Addendum 106 – UN Regulation No. 107

Revision 6 - Amendment 9

Supplement 9 to 06 series of amendments – Date of entry into force: 25 September 2020

Uniform provisions concerning the approval of category M₂ and M₃ vehicles with regard to their general construction

"Figure 31

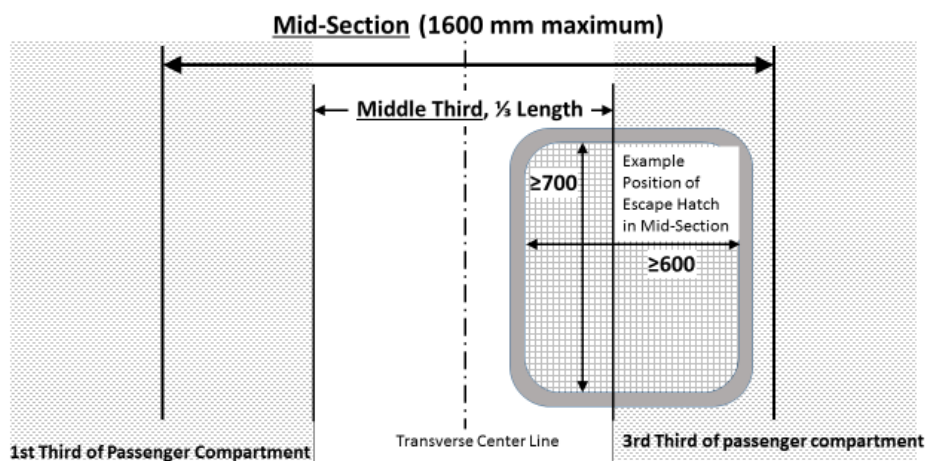
After Figure 30 insert a new Figure 31 to read:

Alternative placement of escape hatch for very short passenger compartment length having a middle third smaller than 1600 mm

"7.6.2.9. For vehicles of classes A and B, required escape hatches shall be positioned as follows:

- (a) If there is only one hatch, it shall be situated in the middle third of the passenger compartment. As an alternative, on vehicles with a very short passenger compartment length, the hatch may be located in the mid-section of this compartment, and this mid-section shall be equally spaced longitudinally each side of the transverse centre line of the passenger compartment, with a length of no greater than 1.6m as shown in Annex 4, Figure 31;
- (b) If there are two hatches, they shall be separated by a distance of at least 2 m measured between the nearest edges of the apertures in a line parallel to the longitudinal axis of the vehicle."
